10th November 2021

Our Ref. 20080

Re: Planning & Development Act 2000 and the Statutory Regulations made thereunder (as amended). Third party observation by Ballyboden Tidy Towns Group, 17 Glendoher Close, Rathfarnham, Dublin 16; in relation to a Strategic Housing Development for the construction of 131 no. residential units (21 no. houses, 110 no. apartments), crèche, retail unit and associated site works at Stocking Lane, Ballyboden, Dublin 16.

An Bord Pleanála Ref. TA06S.311616

Figure 25: Building Heights

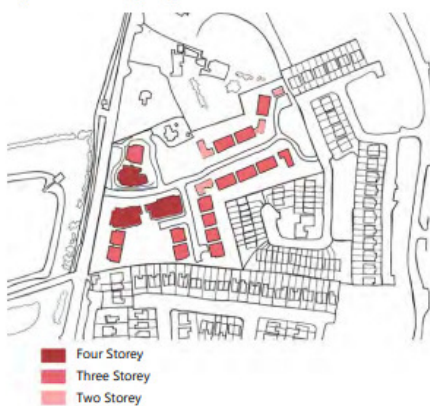
Springvale (adjoining the sites southern and eastern boundary). The increasing of heights at the boundaries of the site is in complete contravention of this policy objective, and is a strong grounds for refusing permission in this instance.

We refer the Board to the positioning of the proposed standalone apartment Blocks – including Blocks H, J and K (all 3 storey) that are all located in close proximity to the southern boundary of the subject site close to the rear gardens of the existing dwellings at Prospect Heath and Prospect Avenue. We also note that the Landscape drawing no. 1490-2012 prepared by PC Roche identifies that basement vents are to be located at the boundary of the site with adjoining properties to the south.

The proposed site layout plan (drawing no. 2183-12-A) prepared by Matt Barnes Architects identifies that Block H is c.4.2 m, Block J is c. 2.3 m and Block K is c. 6.6 m from the southern site boundary. The gable end of these blocks address the southern boundary of the site. The gables are 3 storey overall, designed as blank featureless elevations which will have an overbearing impact on the rear gardens of the existing residential properties at Prospect Avenue and Prospect Heath. The location of the proposed Apartment Blocks in close proximity to the boundary of the site as well as their orientation and poor articulation proximate to the existing dwellings will have a negative impact on the residential amenities (i.e the rear gardens) of these properties.

CGI Proposed View 4 (proposed cycle/pedestrian link to Springvale) and Extract from Aecom's Traffic & Transportation Assessment (Figure 3.3)

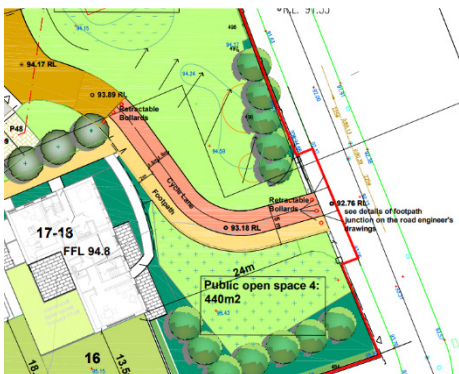
The proposed site layout plan (extract provided below) prepared by Matt Barnes Architects refers to the provision of “retractable bollards” at two points along the pedestrian/cyclist access to Springvale. The reference to “retractable” is of concerns as it leads one to believe that the proposed pathway could be potentially utilised by vehicles at some point in the future.

We note that section 12 of the Planning Report, Statement of Consistency and Material Contravention (which is a combined report) prepared by MDB refers to a “pedestrian, cyclist and **emergency access to Springvale**”. (bold our emphasis). We note that this statement is at odds with the wording in section 4.4 of the very same report by MDB which specifies that “The access road to the east to Springvale is proposed with **fixed bollards. The access will be used for pedestrians and cyclists**”. (our emphasis). There are conflicting descriptions within the applicant’s reports as well as the drawing material submitted with the SHD material.

The use of the access to Springvale for emergency access purposes is not expressly set out in the statutory notices nor is it referenced or addressed in the Traffic and Transport Assessment report prepared by Aecom. The notices simply refer to “A new pedestrian and cycle access to the Springvale estate to the east.” The application in this case has identified on the one hand that the access to Springvale is for pedestrian and cyclist linkages (as per the statutory notices) while on the other hand identifying it is also to provide emergency access (within the MDB report). There are no further details relating to the nature of the emergency access nor how it is to be management by whom and under what circumstances. Despite the applicants acknowledgement within the MDA report that “There was also significant local opposition to this link to Springvale from the residents of that estate” relating to the previously refused SHD development at the subject site, the SHD documentation and particulars has failed to provide, in our considered opinion, sufficient clarity in relation to the proposed link and access at Springvale and its intended function. These are fundamental omissions from this SHD planning application which are of particular concern to our clients.

Landscape Plans – shows vehicular, pedestrian and cyclist access via Springvale

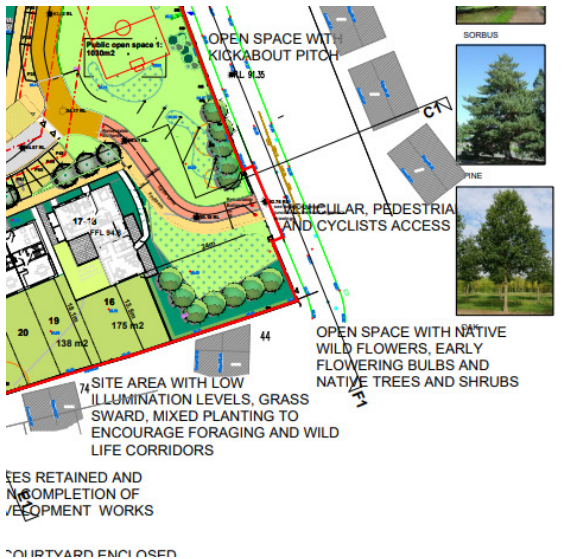
In addition we note that the Landscape Strategy Proposal drawing no. 1490 -2011 prepared by PC Roche includes a label in close proximity to Springvale which refers to a “Vehicular, Pedestrian and Cyclist Access” (refer to the extract from the drawing below). Again this drawing does not represent the proposals referenced in the statutory notices which identifies the access to Springvale as pedestrian and cycle not for vehicular purposes. The landscape drawing is at odd with the statutory notices.

The Landscape report does not appear to be referring to the revised SHD development as per the statutory notices. It is not clear if the final version of the Landscape Report has been included on the SHD website.

FIGURE 2.1: PROPOSED ACCESS ROAD FROM STOCKING LANE

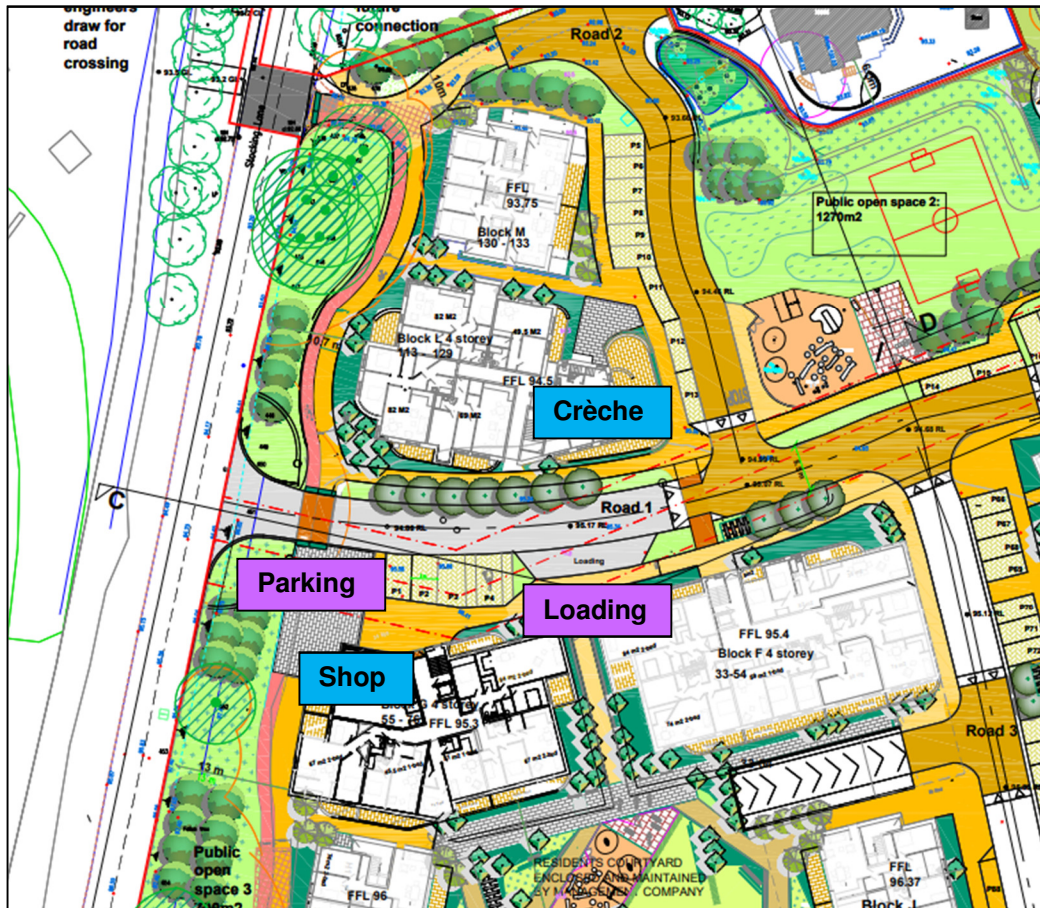
- 1.1.24 The site layout consists of a relatively straight vehicle access road in the centre of the site leading west to east.
- 1.1.25 The initial section of this access road (referred to as Road 1) is shown in **Figure 2.1** overleaf. It can be seen that the shop, crèche and associated parking/loading are all located in close proximity (50-60m) to the access junction with Stocking Lane. It is our view that this arrangement will lead to localised congestion on the access road when deliveries occur and at peak times for the crèche/shop, which could lead to road safety problems.

- 1.1.28 It is our view that the presence of on-street parking (of any type) on both sides of Road 4 over a distance of more than 100m leads to a car dominated development, which is not helpful when seeking to encourage residents to travel by alternative modes of transport.

FIGURE 2.2: MINIMUM FOOTWAY WIDTH FROM DMURS

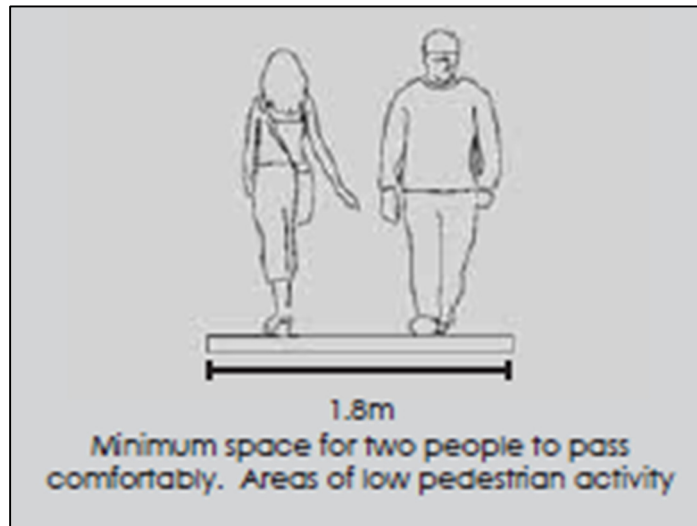
- 1.1.29 SDCC's Opinion on the SHD submission dated 13th June 2019 states that the internal roads should be 6m wide due to the presence of perpendicular parking as "*they are going to be busy distributor streets with refuse and emergency vehicles using them*". However, the internal roads are proposed to be 5.5m reducing to 4.8m in places.
- 1.1.30 The reduced width and presence of car parking on both sides means that the main access road within the site (Roads 1 and 4) will lead to potential conflict between road users and resultant road safety problems.
- 1.1.31 The TTA states in section 4.4 that "*internal footpaths are proposed to be a minimum of 1.8m*". DMURS identifies 1.8m as the minimum width to allow two people to pass comfortably as shown overleaf in **Figure 2.2** (itself an extract from Figure 4.34 in DMURS) and suitable for areas with "*low pedestrian activity*".

- 1.1.32 This appears to be at odds with Section 4.4 of the TTA, which states that *“it is proposed to provide high quality pedestrian and cycle access throughout the site”* as the minimum footway width is proposed and is hardly worthy of being described as *“high quality”* in space terms alone.

- 1.1.33 Moreover, such a width is suitable for areas with *“low pedestrian activity”* rather than within a new residential neighbourhood that purports to be sustainably located and where one of the objectives of the submitted Mobility Management Plan (MMP) is to *“increase and facilitate the number of people choosing to walk, cycle or travel by public transport”*.

FIGURE 2.3: DESIRABLE FOOTWAY WIDTH FROM DMURS

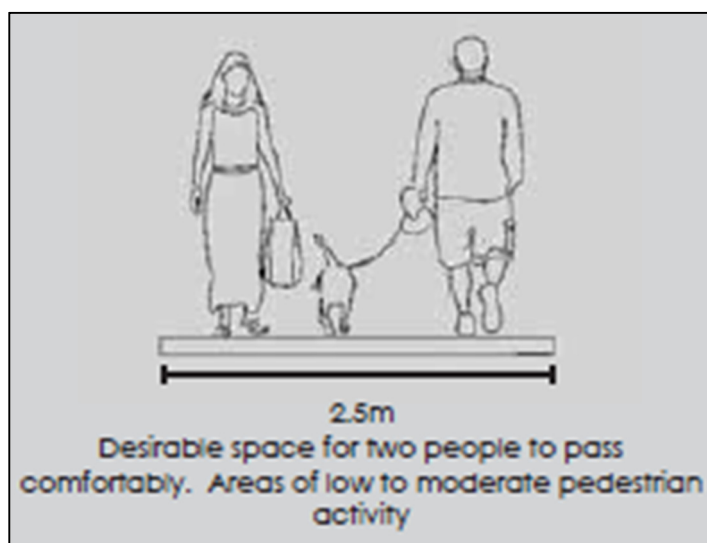
- 1.1.34 It is more likely that this objective could be achieved if, at the very least, footways of 2.5m were proposed within the development site as deemed *“desirable”* in DMURS and shown below in **Figure 2.3** (also an extract from Figure 4.34 in DMURS).

FIGURE 3.1: LOCAL FACILITIES WITHIN 500M OF THE SITE (FROM SHD APPLICATION)

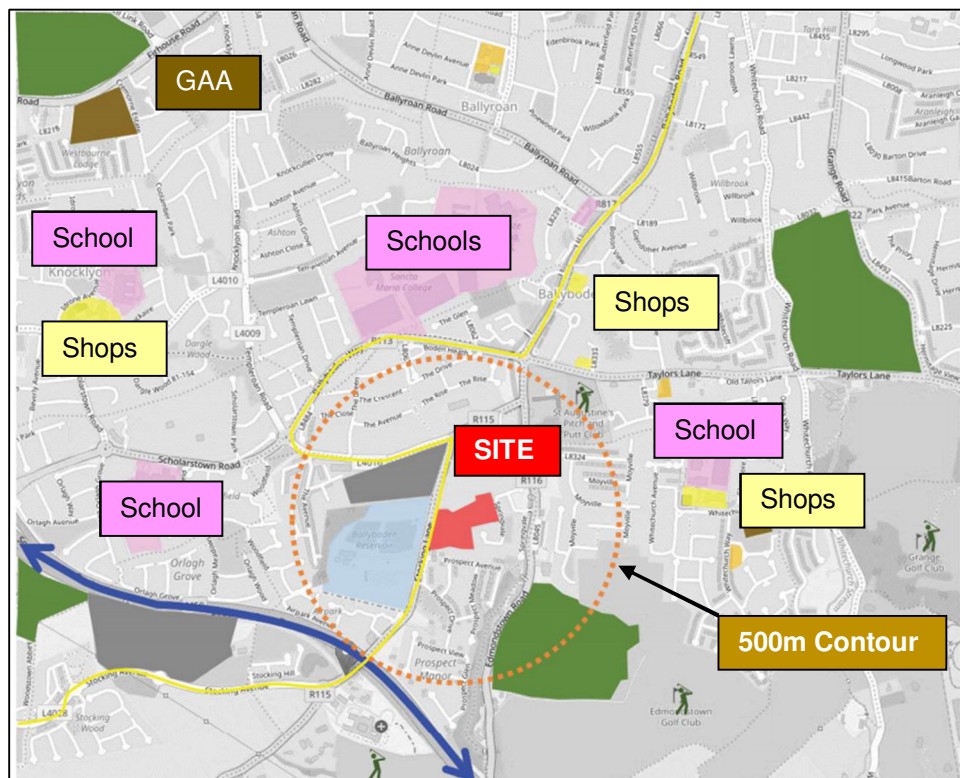
1.1.46 **Figure 3.1** overleaf shows the local facilities within 500m (as the crow flies) of the site, which is a 6 minute walk. This has been extracted from the *Stocking Lane Concept Plan and Design Criteria Statement* submitted with the SHD application. It can be seen that the only “facilities” within 500m of the site (the distance selected to be shown by the applicant presumably to identify an appropriate walking distance) are the Reservoir and part of Edmondstown Park; neither of which are likely to be frequented regularly, if at all, by future residents.

The vast majority of the more useful facilities (schools, shops, community facilities, medical facilities, sports pitches etc) are located between 1km and 2km of the site (by the shortest walking route). These distances cannot be considered ‘close’ particularly if carrying shopping bags either by hand or on

FIGURE 3.4: COMMITTED DEVELOPMENT IN THE AREA

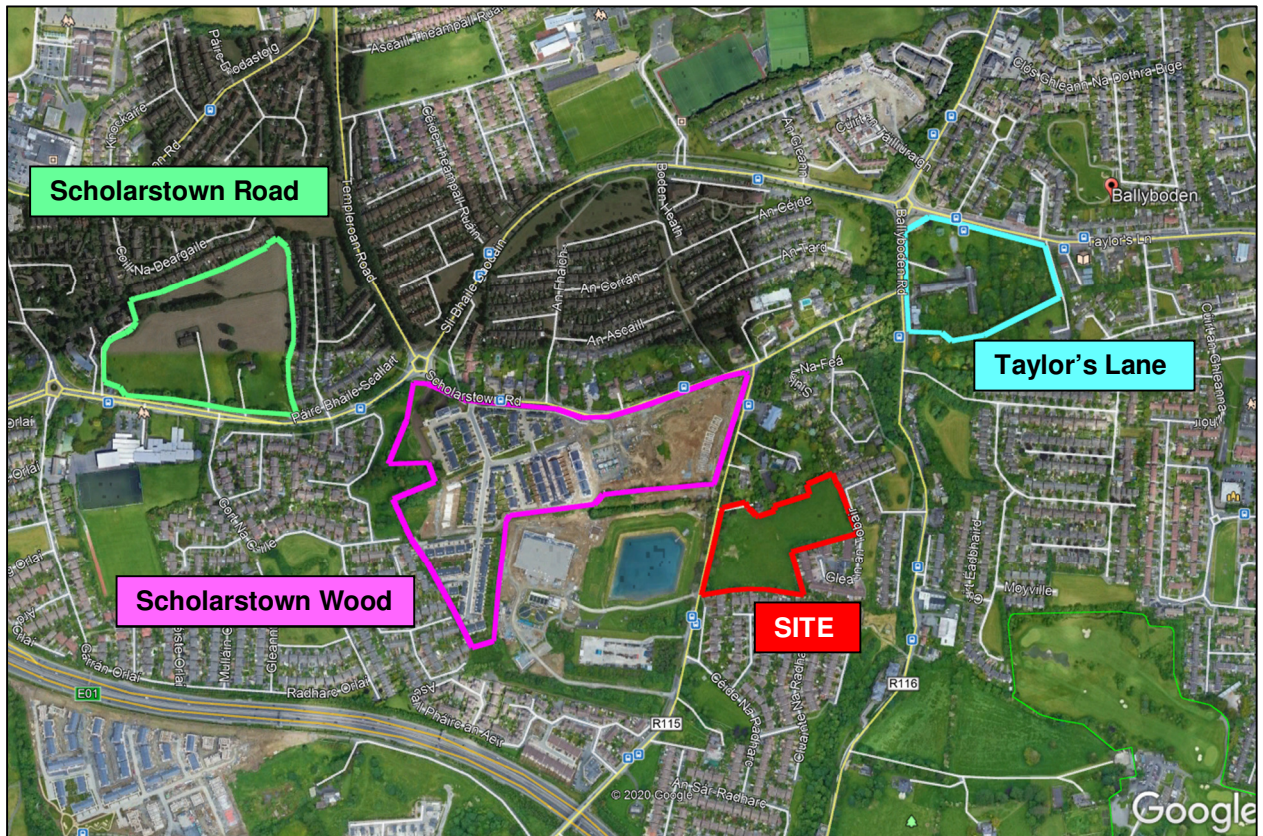
- 1.1.58 In all of the above it should also be noted that the Stocking Lane SHD proposal is not the only proposed development site in the local area as shown in **Figure 3.4** below.

1.1.60 As such, the local population will increase significantly, which will be a considerable strain on the operation of the current/proposed public transport services. This is a fundamental issue as public transport services could be operating at capacity. No evidence has been provided to show that the public transport services will remain within capacity once all of the committed and proposed developments have been completed. This needs to be considered fully before planning permission can be granted.

FIGURE 5.3: KEY JUNCTIONS AND COMMITTED DEVELOPMENT IN THE BALLYBODEN AREA

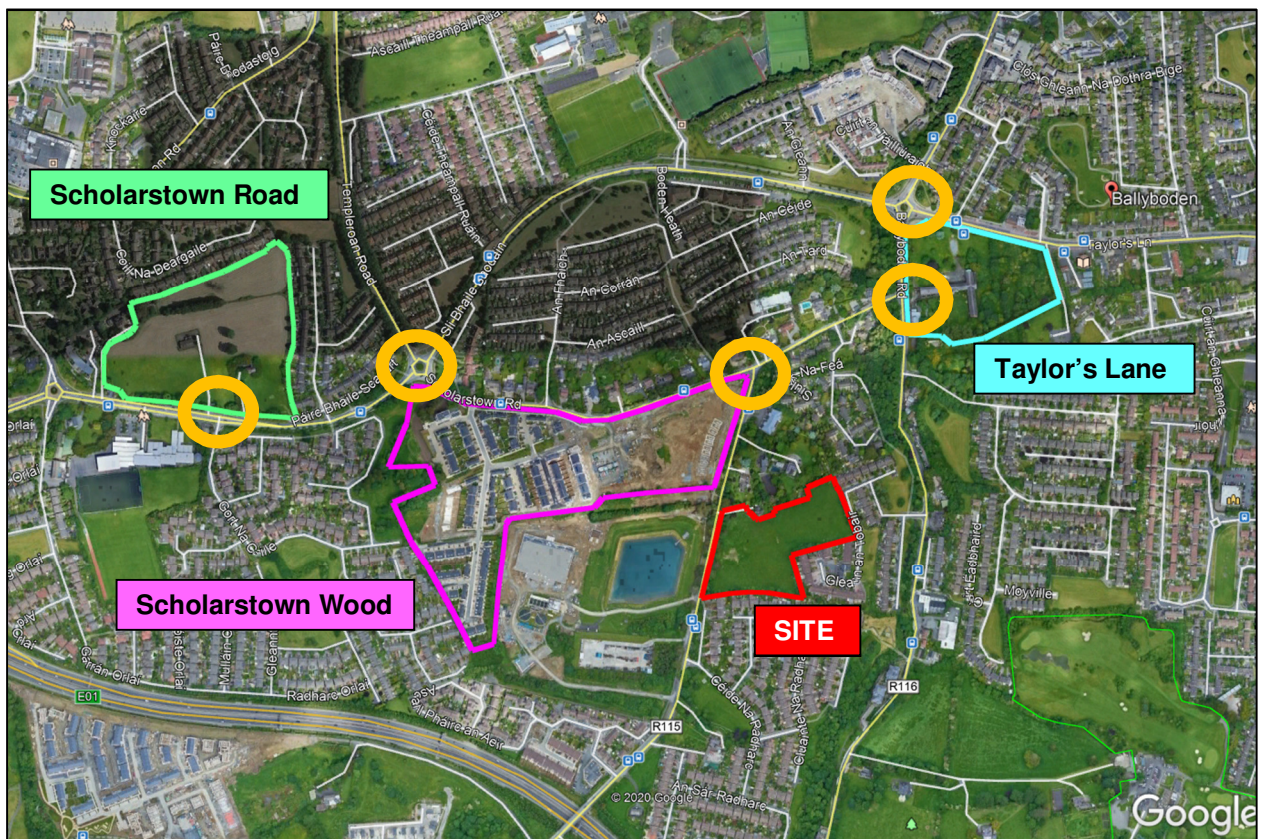
1.1.85 It has already been noted that over 1,400 residential units have been permitted by ABP at the sites in the Ballyboden area shown below in **Figure 5.3**.

1.1.86 The junctions identified in **Figure 5.1** in orange been assessed as part of the various SHDs in the Ballyboden area. However, each TTA has only looked at the operation of these junctions in relation to their own specific development and so the cumulative impact of the additional traffic upon these key junctions is unknown/untested.

1.1.87 Given that traffic from the Scholarstown Wood and Scholarstown Road (as well as the SHD site being considered in this Technical Note) will also result in additional traffic routing via this junction, it is highly likely that queuing vehicles will extend back to the Scholarstown Road/Stocking Lane junction as it is located only 250m to the west. The queue was already at 140m with only the traffic from the Taylor's Lane SHD added and so will increase significantly when the three other SHD sites (comprising over 1,000 residential units) also send new traffic through this junction.
